SUBDIVISION REPORT - CONCEPT

▶ **FILE #:** 2-SB-23-C **AGENDA ITEM #:** 7

▶ **SUBDIVISION:** BUFFAT MILL ESTATES

Requested Variances & Alternative Design Standards

LAYOUT AND PAVING PLAN

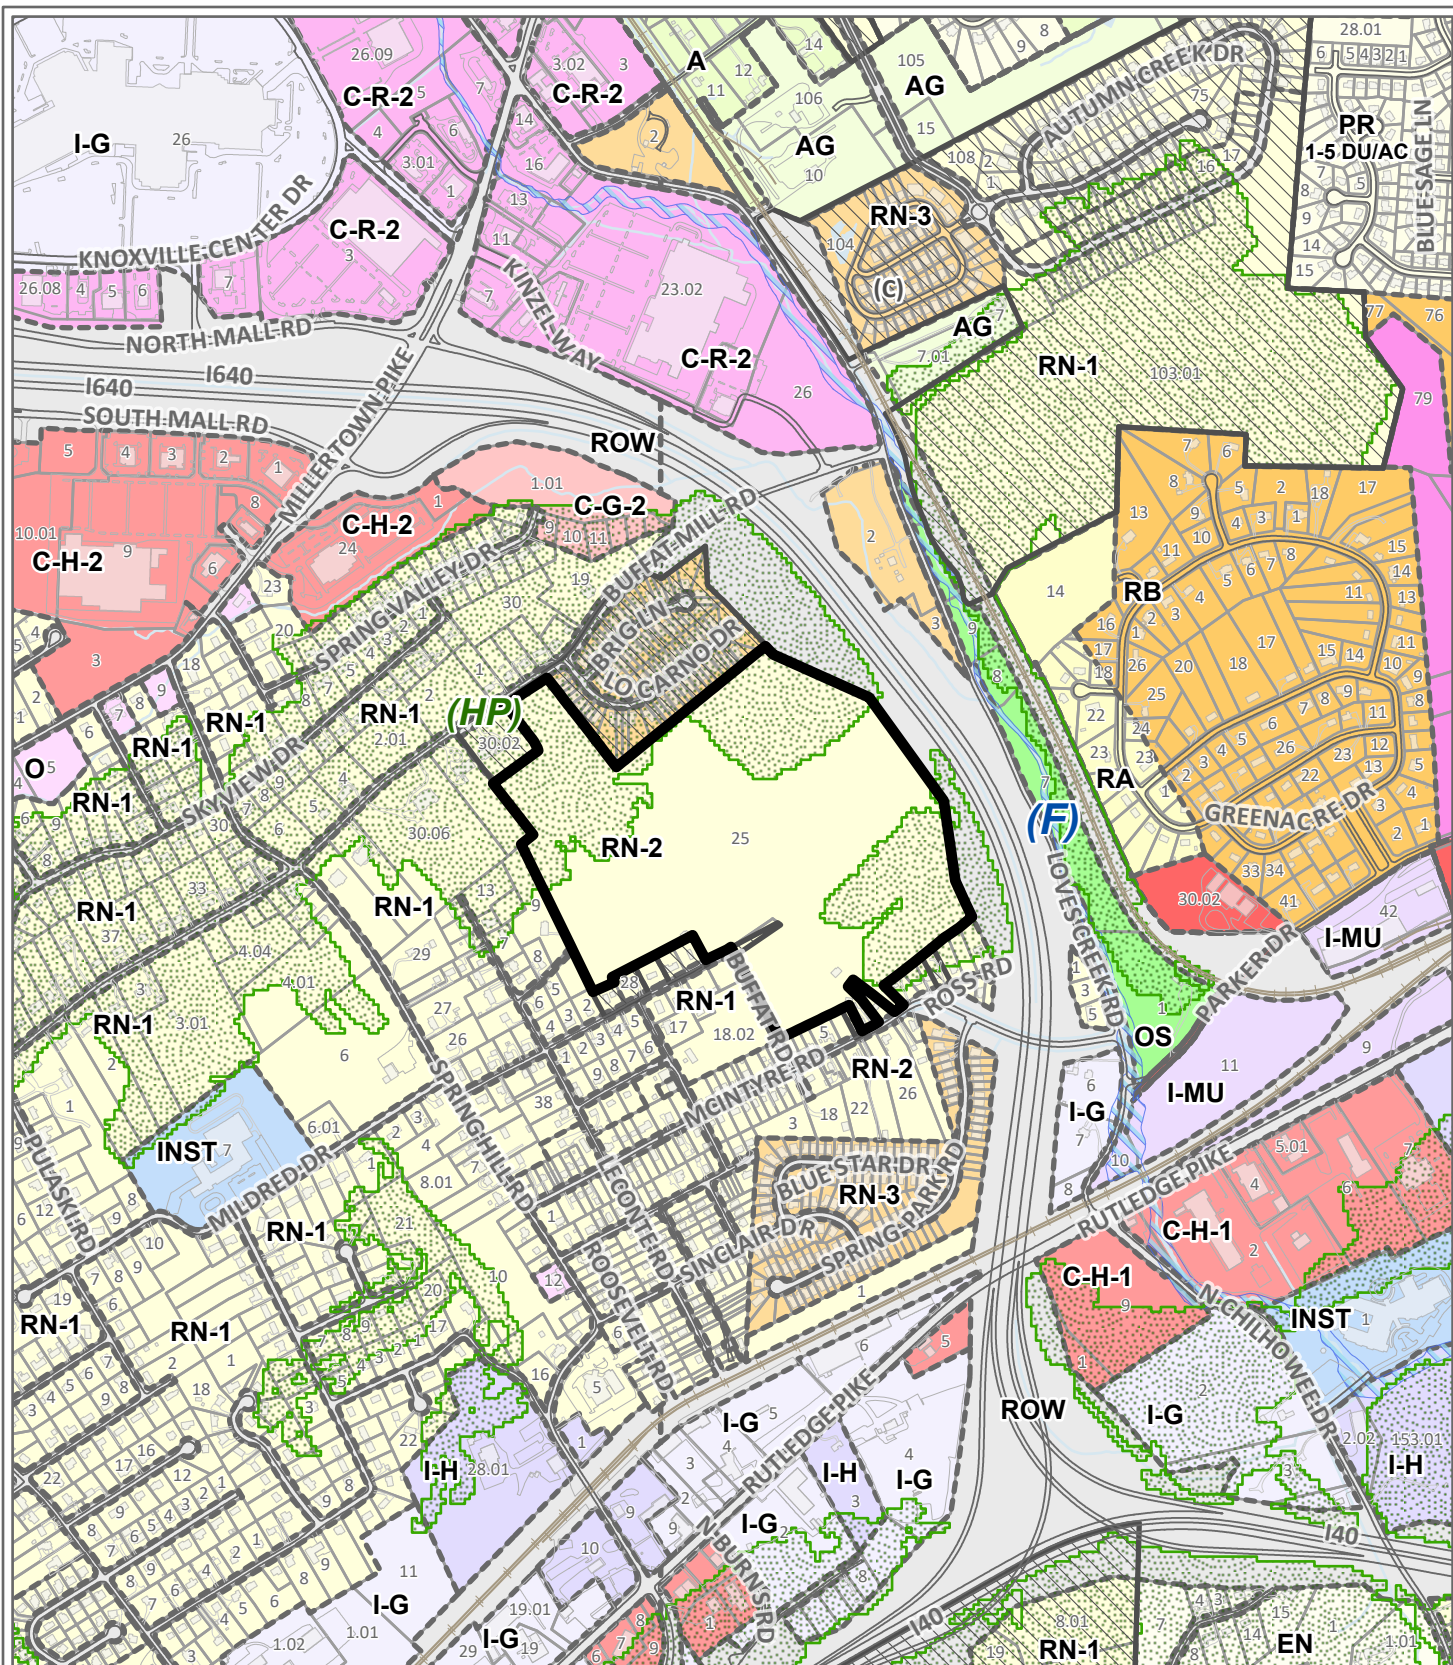
▶ **SUBDIVISION VARIANCES REQUIRED:** **VARIANCES**
1. Reduce the minimum intersection separation from 300 ft to 190 ft between the centerlines of Road 'A' and Locarno Drive.

The proposed Road 'A' intersection at Buffat Mill Rd requires an intersection separation variance from 300 ft to 190 ft to Locarno Dr. There is limited opportunity to shift the access point further away from Locarno Dr. The reduced intersection separation is less of a safety concern because the intersections are on the same side of the street and will not create conflicting turn movements on Buffat Mill Rd.

- REDUCE INTERSECTION SPACING FROM 300' TO 190' FOR ROAD "A" & LOCARNO DRIVE

- **Approve the requested variance and alternative design standard based on the justification provided by the applicant and recommendations of the City of Knoxville Department of Engineering.**

The City of Knoxville recommends consideration of these variances.

PRELIMINARY GRADING PLAN

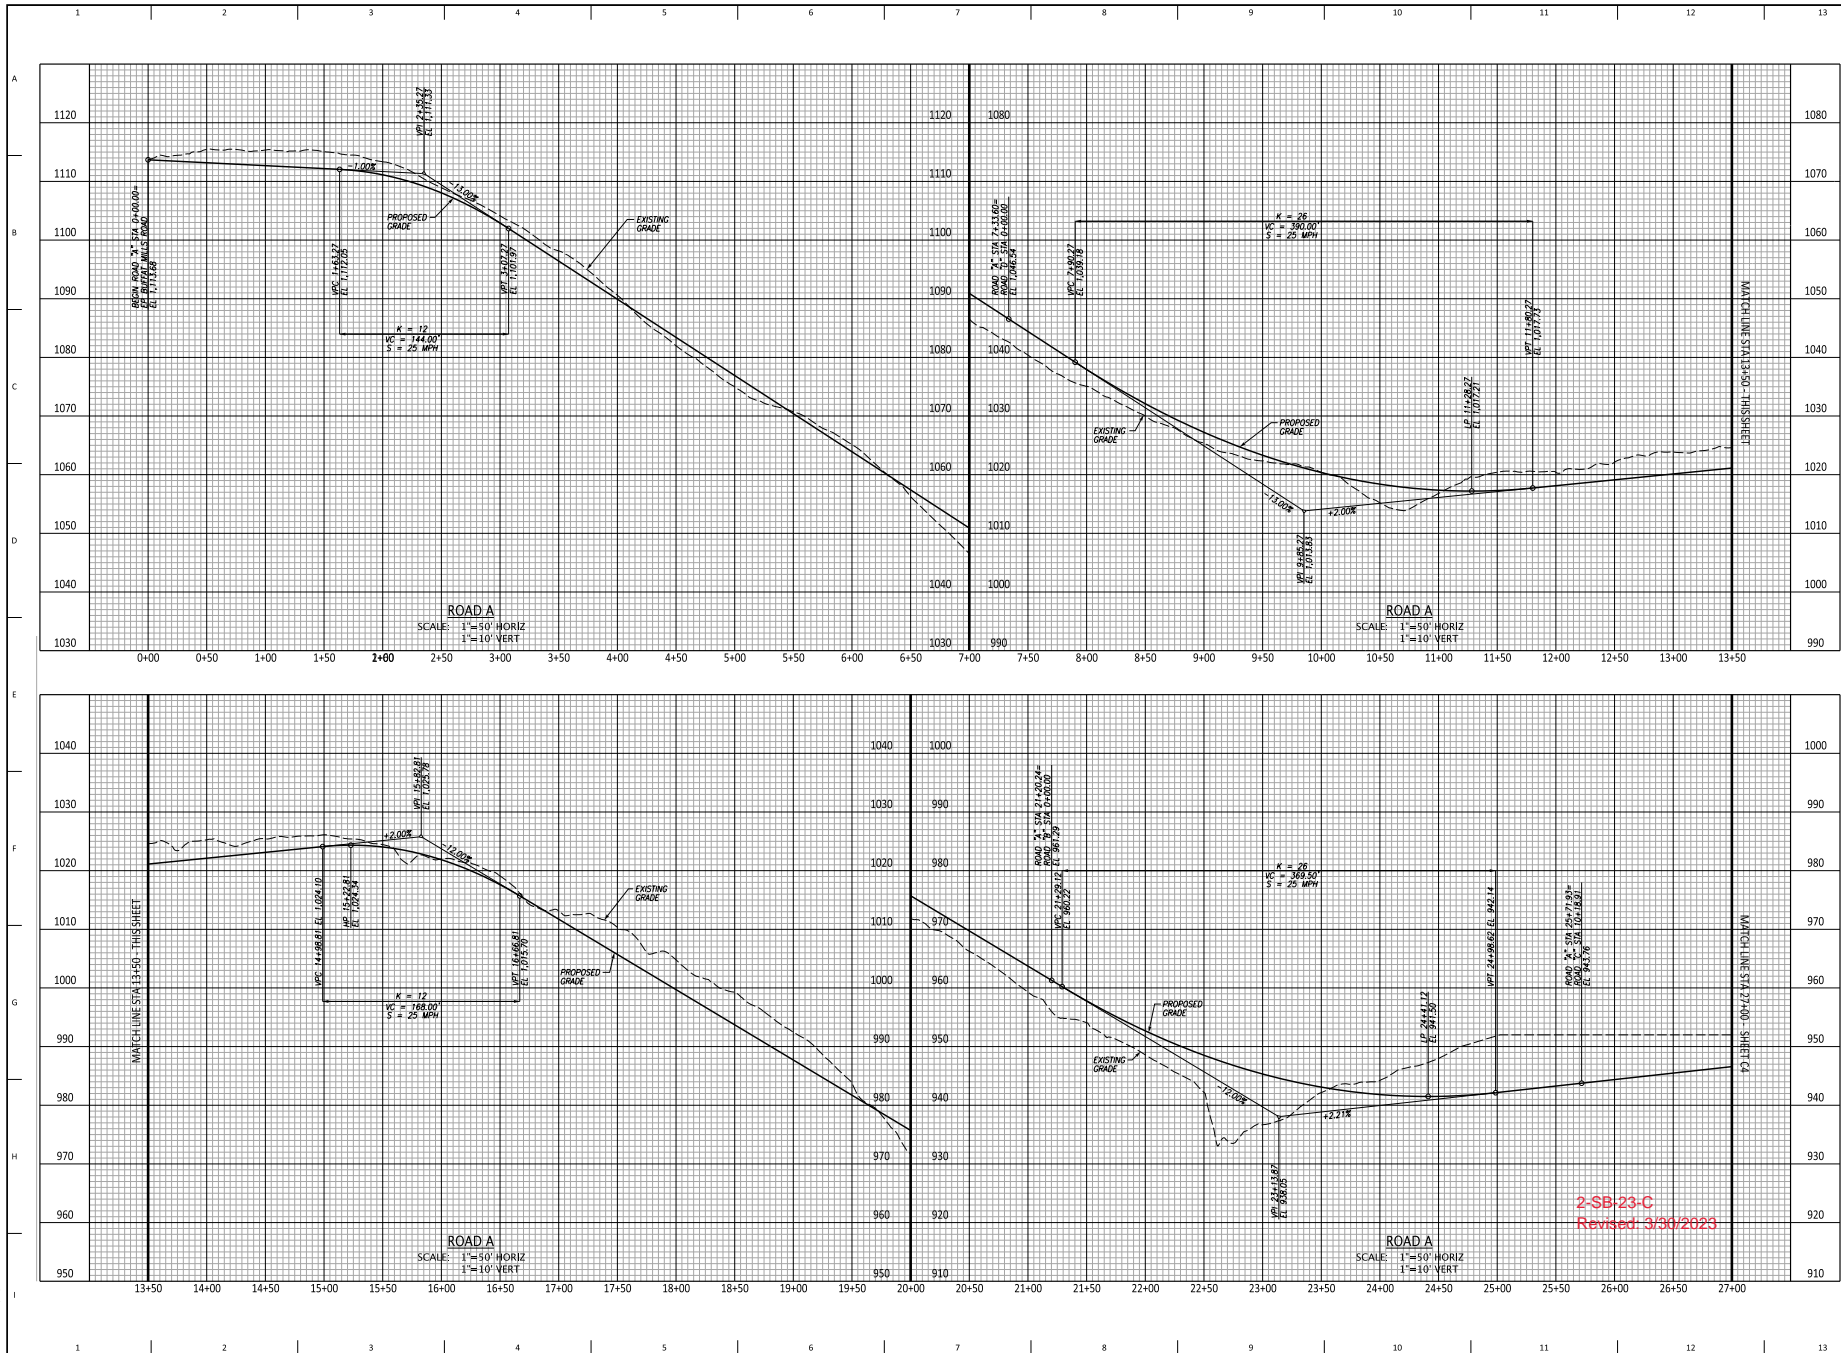
Approximately 28 acres of the site are in the HP (Hillside Protection Overlay) zone. A maximum of 19.13 acres within the HP overlay can be disturbed. The applicant proposes to disturb 19.15 acres. Conformance with the disturbance limitations must be confirmed during the design plan phase.

5. Provide sight distance easements on the final plat as required by the Knoxville Department of Engineering during the design plan phase.
6. Confirm that the land disturbance complies with the HP (Hillside Protection Overlay) zone district during the design plan phase.

ROAD PROFILES

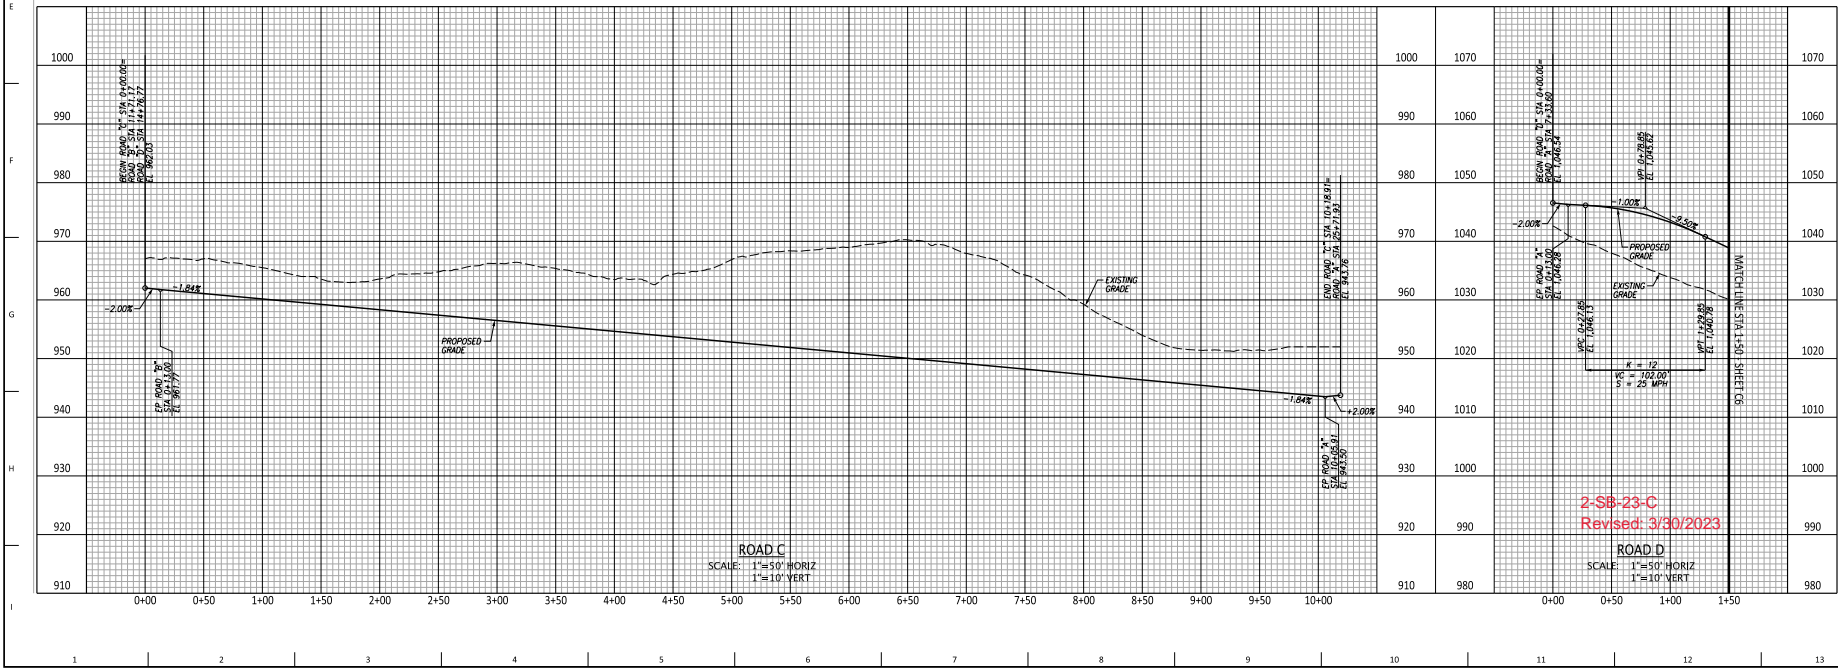
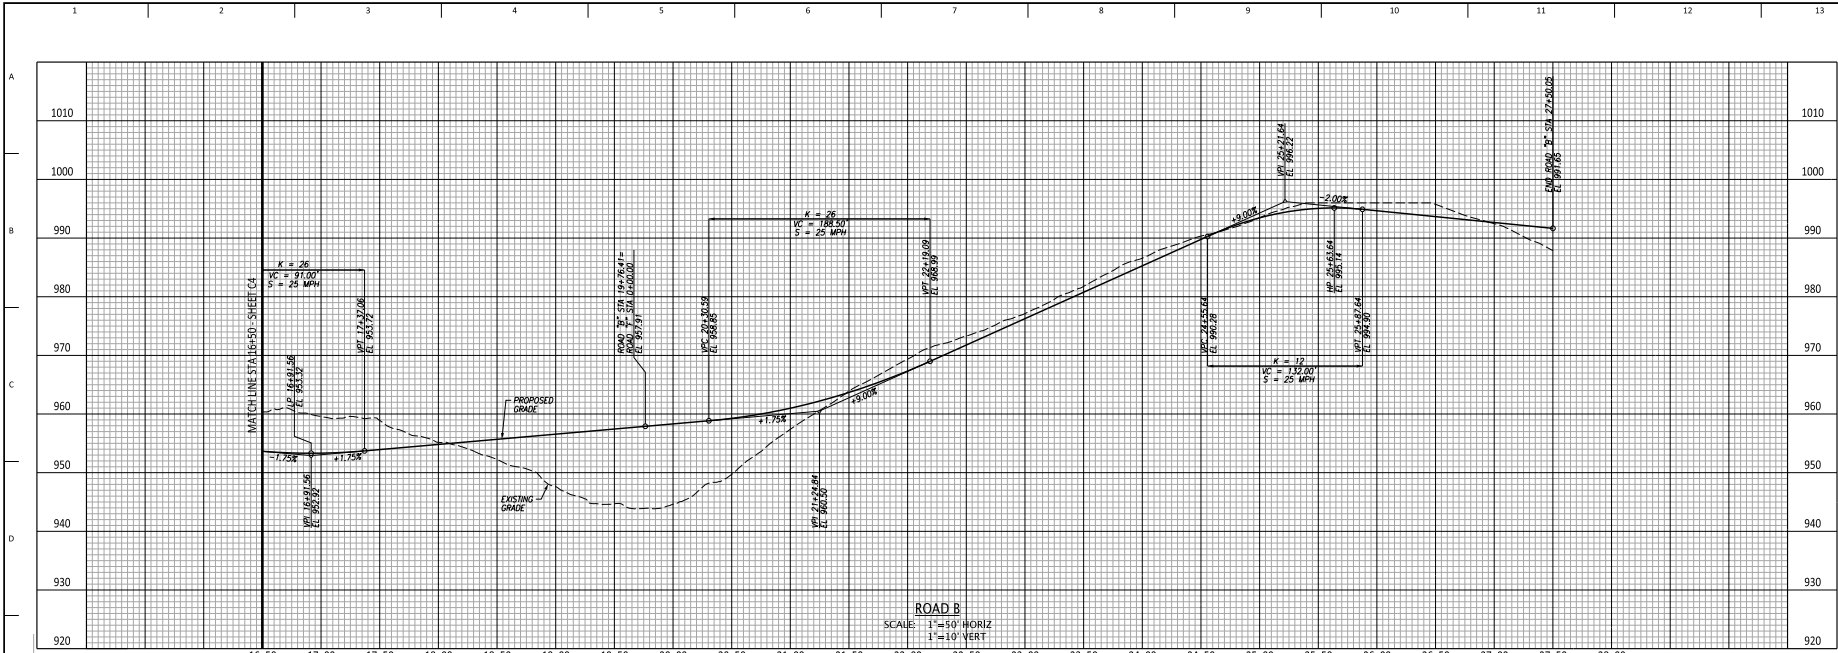
1. Increase the maximum road grade from 12 percent to 13 percent on Road 'A' between STA 3+07.27 and 7+90.27

Buffat Mill Road at Roadway Connection (Road "A")
Intersection Sight Triangles

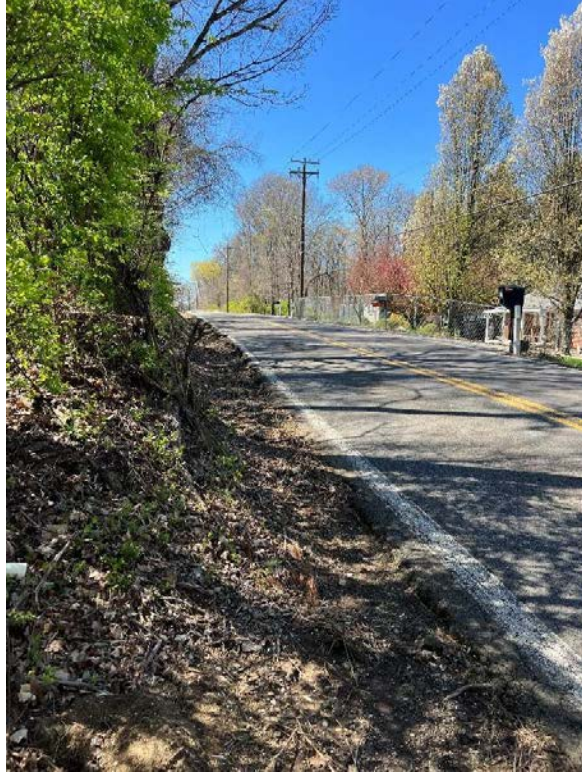
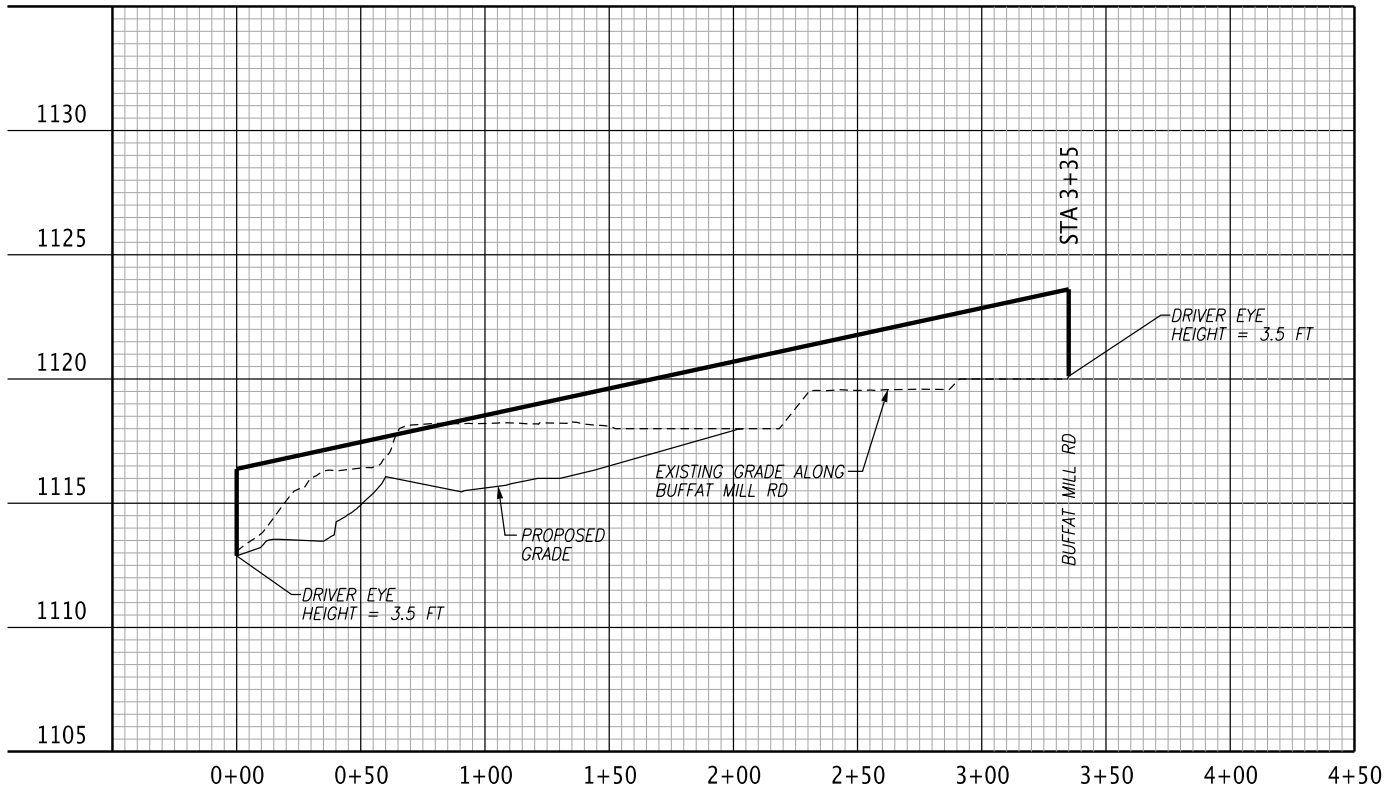
Ardurra recommends that the intersection sight distance be certified by a land surveyor prior to construction in order to verify that Buffat Mill Road has adequate intersection sight distance at the proposed roadway connection (Road "A") to comply with City of Knoxville and AASHTO requirements. No sight distance easement will be needed.

The intersection sight triangles at the intersection of Buffat Mill Road at the Roadway Connection (Road "A") do not show that any easements will be required from the adjoining properties. Any required sight distance easements for the internal subdivision intersections should be coordinated with the City of Knoxville Department of Engineering and included on the final design drawings prior to construction of the residential development.

4. Certifying that the required sight distance in both directions is available at the intersections of Buffat Mill Rd, McIntyre Rd, and, if required during the design plan phase, the interior intersections. Documentation shall be provided to and approved by the Knoxville Department of Engineering during the design plan phase.
